## Car Stereo Service Bulletin

**Model:** CDX-5040/5080/7540/7580

**No. 219**

**Subject:** Service Manual Addition: Service Mode Instructions.

**Symptom:**

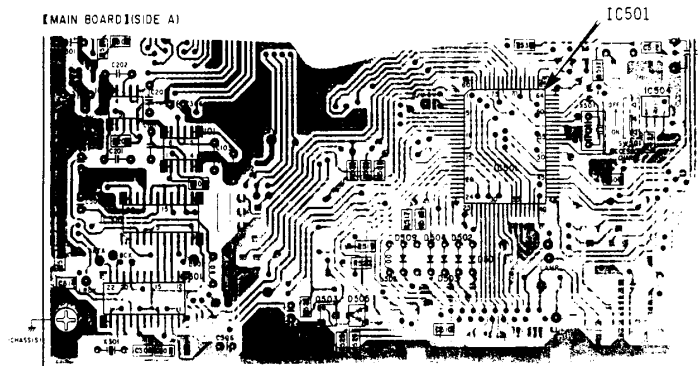
(\*\*) The instructions for entering and exiting the service mode were omitted from the Service Manuals.

**Solution:** Please add the following instructions to your Service Manuals:

"The method of entering the service mode is dependent upon the firmware version of IC501 on the main board. Refer to the chart below to determine which method is applicable to each unit:

"To cancel the service mode, press the *OFF* button, or the *RESET* button."
